UNITED STATES PATENT AND TRADEMARK OFFICE

Office Action Summary

10/714,670

DETAILED OFFICE ACTION

**FIG. 3L****REGARDING CLAIM 14**

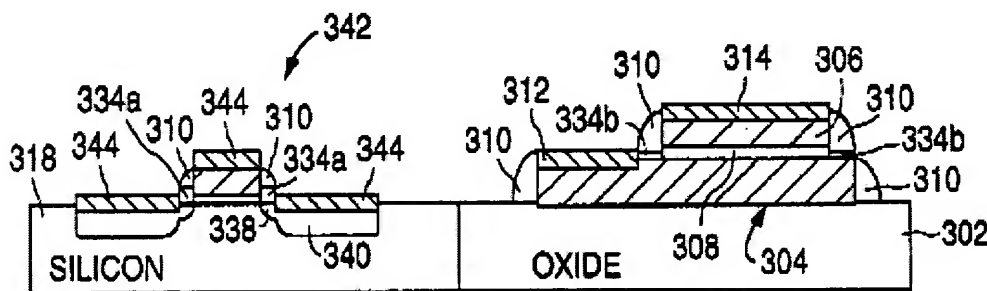
Blair discloses (in fig 3L, in column 5 lines 63-67, column 6 lines 1-9) a method of forming a memory cell, comprising the steps of: forming a transistor including a gate fabricated on a semiconductor substrate and including a source/drain region in the semiconductor substrate disposed adjacent to the gate, the step of forming the transistor including providing a silicide region of the gate; and forming a capacitor adjacent the transistor by providing a first conductive

layer, a dielectric layer and a second conductive layer, wherein the steps of providing the first conductive layer, the dielectric layer and the second conductive layer are conducted prior to the step of providing the silicide region of the gate.

Blair discloses (in fig 3L, in column 6 line 1) a CMOS FET transistor and CMOS (Complementary Metal Oxide) is inherently a MOSFET transistor.
